# **MY1 MONITORING REPORT**

## **Wits End Stream and Wetland Mitigation Site**

## Response to DMS Comment – MY1 (2023)

DMS Project ID No. 100164  
Full Delivery Contract No. 7968  
USACE Action ID No. SAW-2020-00455  
DWR Project No. 2020-0369  
IFB 16-032819, RFQ 16-032819-YD05

**Figure 2. 2023 Replant Map**

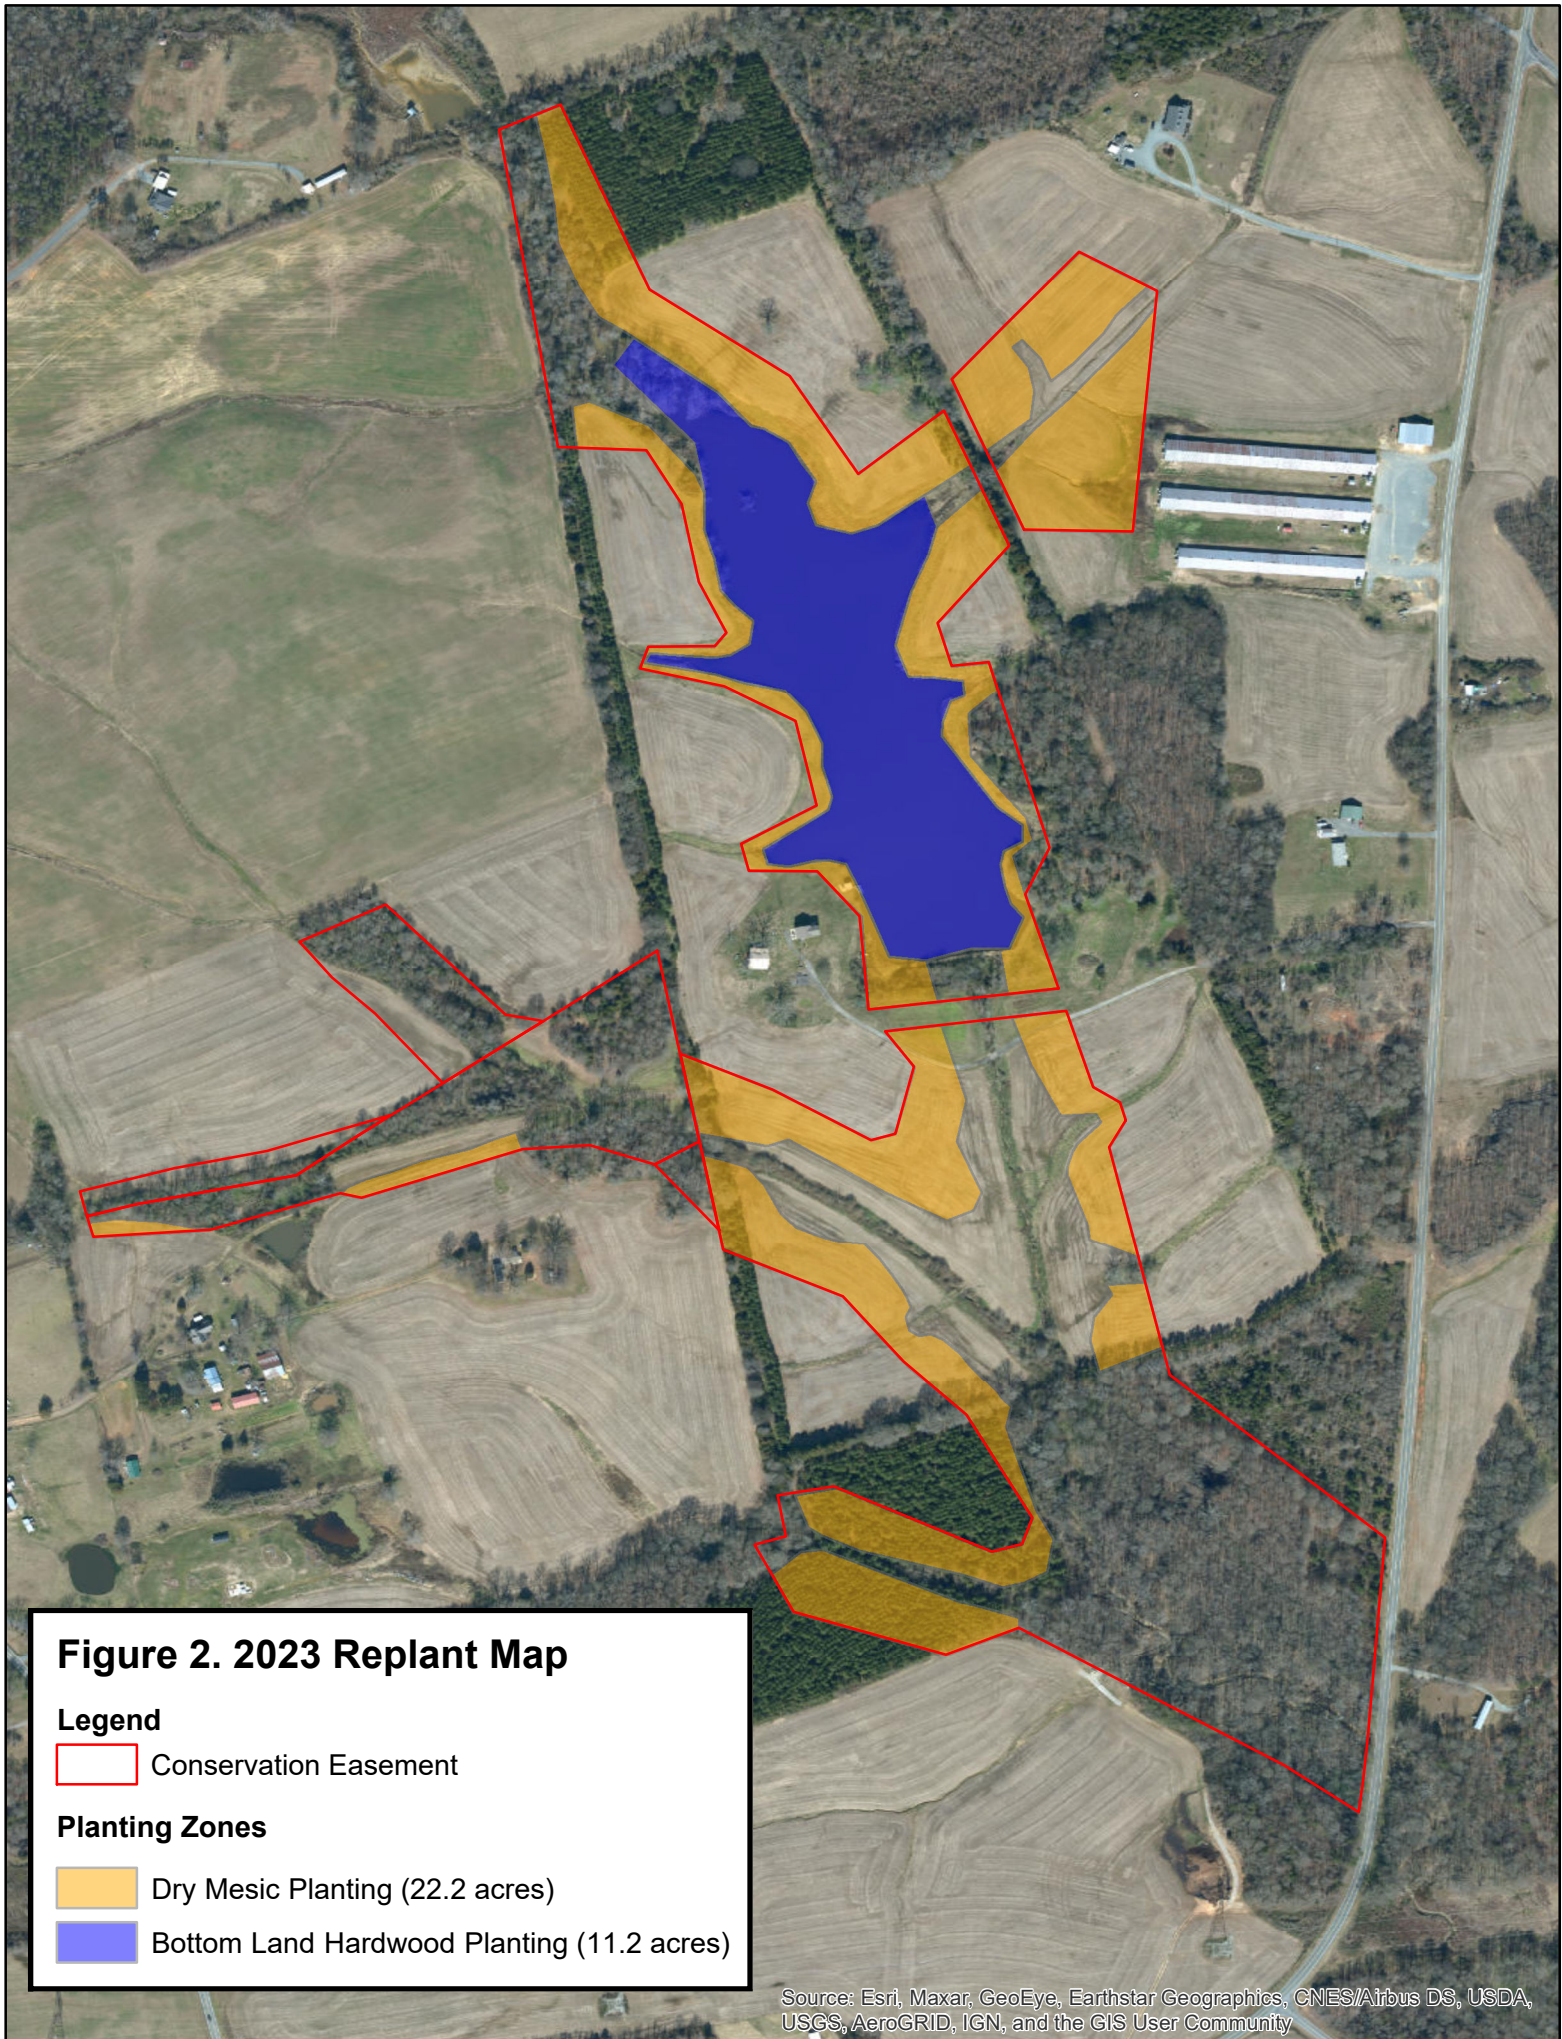
4. 3.2 Vegetative Assessment: When discussing the replant effort that occurred on January 23, 2023, please reference Figure 2 in Appendix A and Table 6D in Appendix B.

**Response:** References to Figure 2 (Appendix A) and Table 6D (Appendix B) were added to the discussion of the January 23, 2023, replanting effort.
5. Please include photos and updates once the Adaptive Management Plan has been implemented in the MY2 report.
